Appendix M9

Key Utility Correspondence

From: Jennifer Vandermeer
Sent: Friday, July 21, 2017 10:36 AM
To: 'tpumarkup@HydroOne.com'
Cc: 'Dana Glofcheskie'; David Argue; Sheridan Park EA
Subject: Sheridan Park Drive Extension Environmental Assessment - Request for meeting with HydroOne
Attachments: 039474 Study Area_SAC_v2_small.pdf; Roll Plan-Prf_500 - Small.pdf

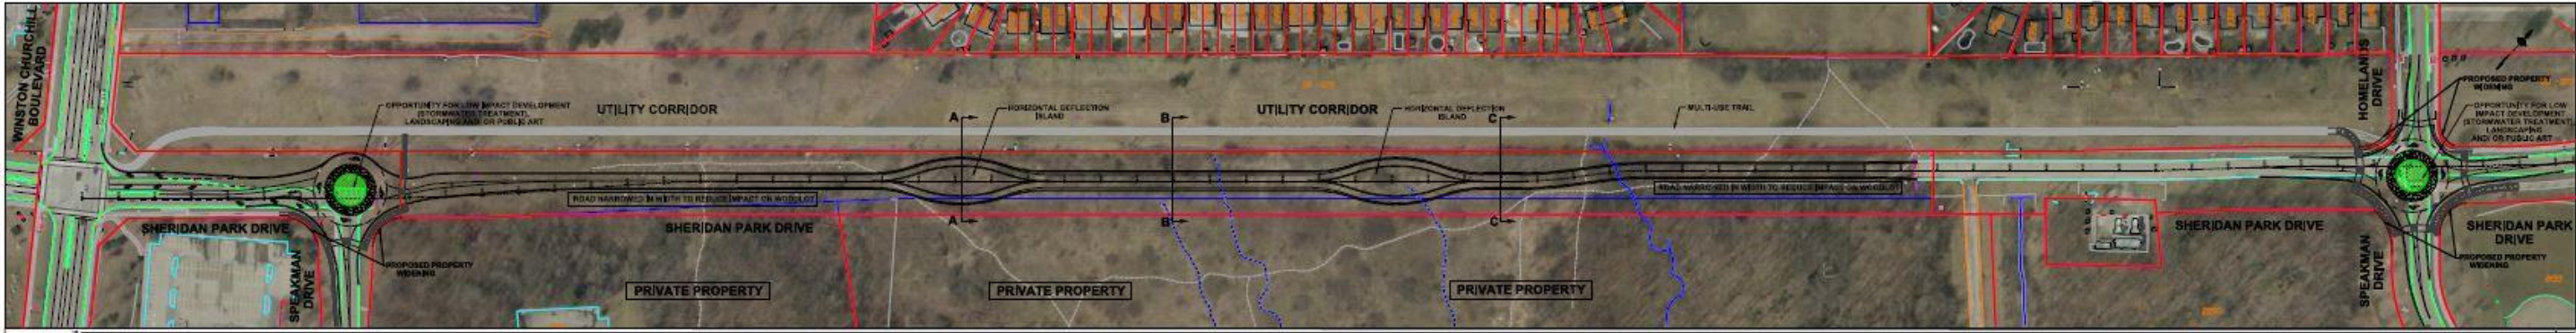
At this point it's too early to meet on this. I looked at the drawing and it appears that you will need to extend the daylight triangles in two locations and add some trail connections. An operational land sale will be required for the daylight triangles and the trail connections will fall within the existing park licence.

There is currently no hydro transmission infrastructure within the hydro corridor so I can't see this being a problem from our perspective. That said, I have included three attachments:

- The first attachment outlines the process involved in obtaining an operational land sale. To begin the process you will need to submit the items listed in the first 5 bullet points.
- The second attachment provides guidance in terms of what we need to see on drawings that you submit for our review. Please ensure that this is followed or the review of the submission may be delayed or returned.
- The third attachment provides some technical considerations when planning new infrastructure near Hydro One plant.
